UNITED STATES  
NUCLEAR REGULATORY COMMISSION  
WASHINGTON, D. C. 20555

FACILITY: Grand Gulf Nuclear Station, Unit 1

SUBJECT: SUMMARY OF AUGUST 14, 1984, MEETING WITH MP&L TO  
DISCUSS EXEMPTION REQUEST - FEEDWATER VALVES

SUBJECT: Grand Gulf Nuclear Station  
Units 1 and 2  
Docket Nos. 50-416 & 50-417  
License No. NPF-13  
File: 0260/L-860.0  
Request for Exemption in  
Accordance with  
10CFR50.12(a) - (10CFR50,  
Appendix J)  
AECM-84/0415

Figure 1: Feedwater System

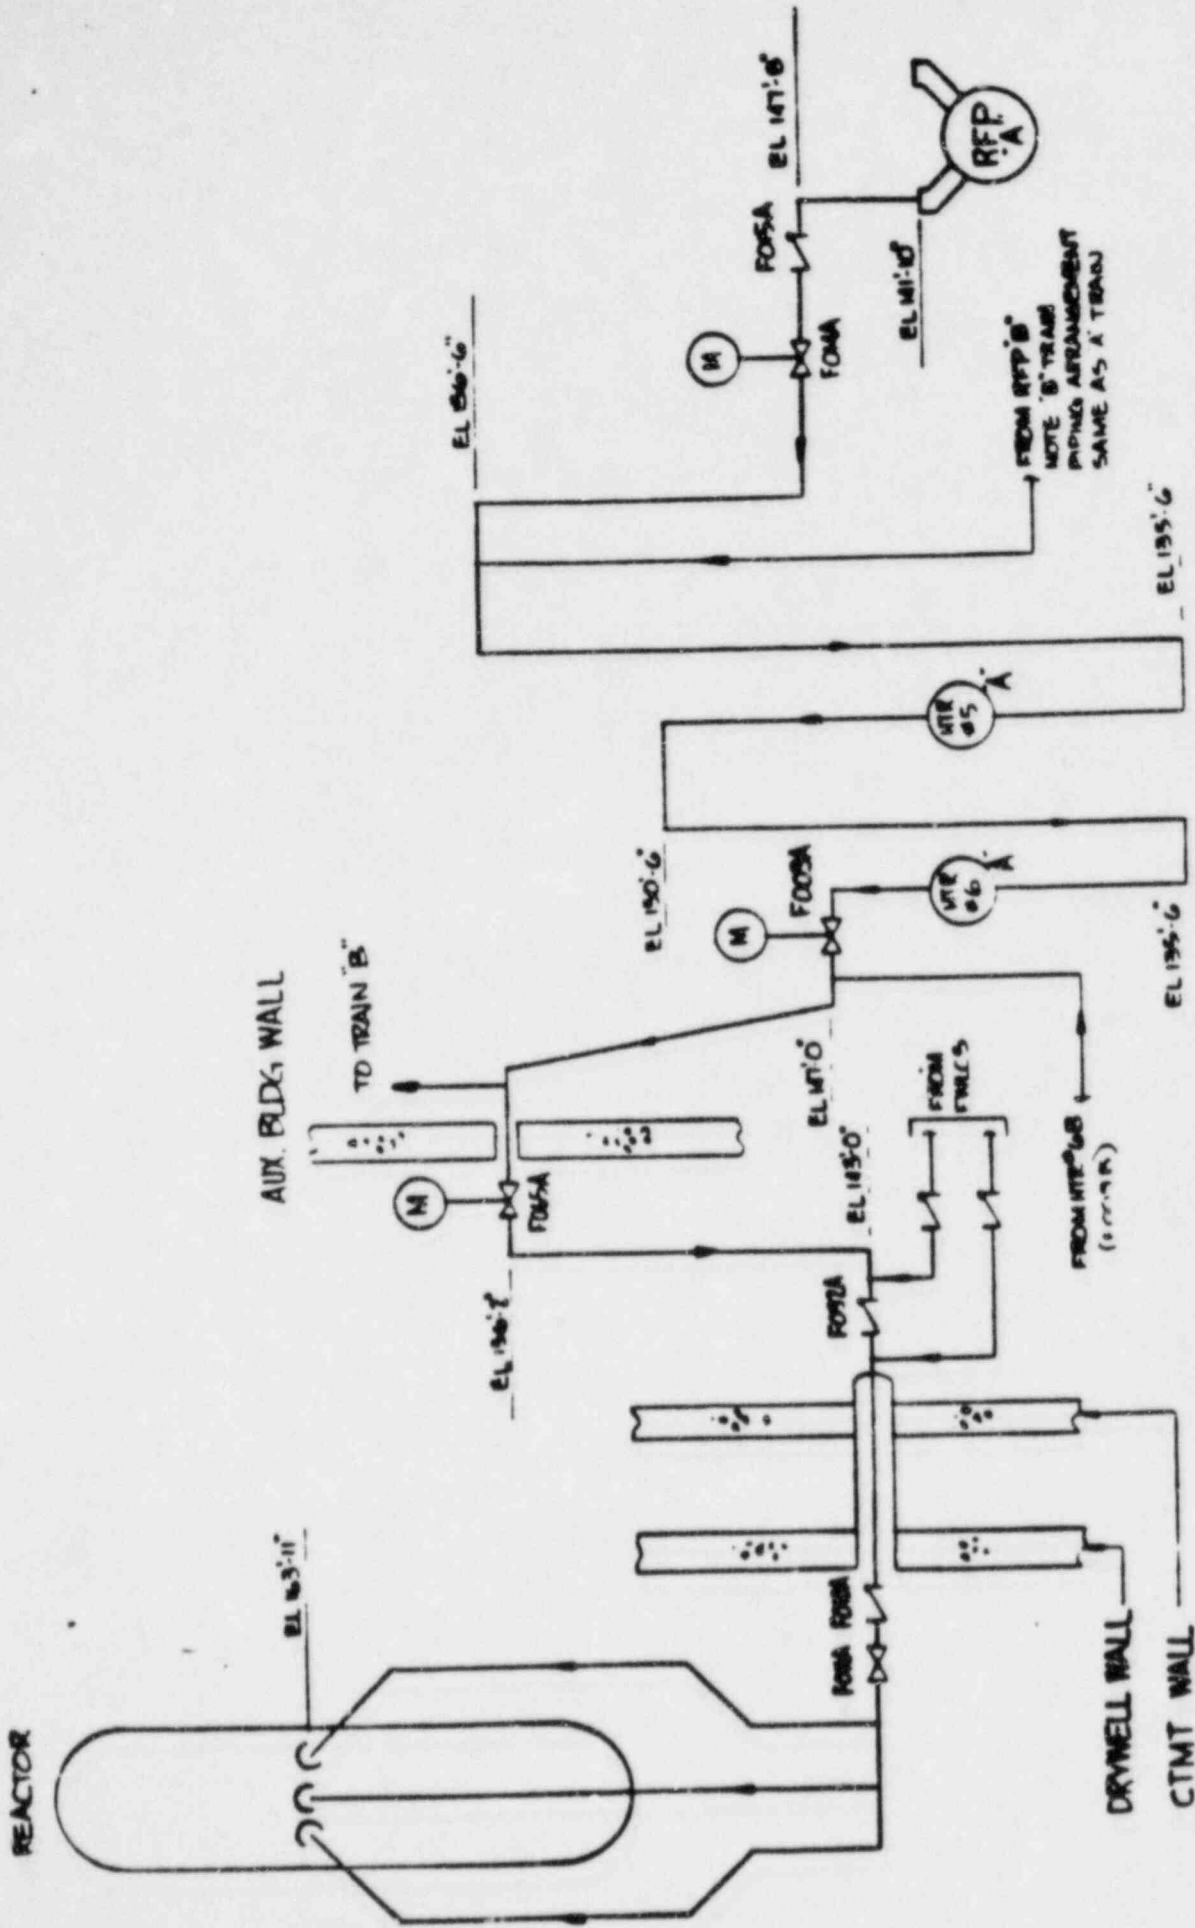
O PENETRATION ARRANGEMENT (SEE FIGURE).

F065 MOV-GATE	STEAM TUNNEL	REMOTE MANUAL
F032 SWING CHECK	STEAM TUNNEL	TESTABLE
F010 "Y" PLUG CHECK	DRYWELL	SIMPLE CHECK
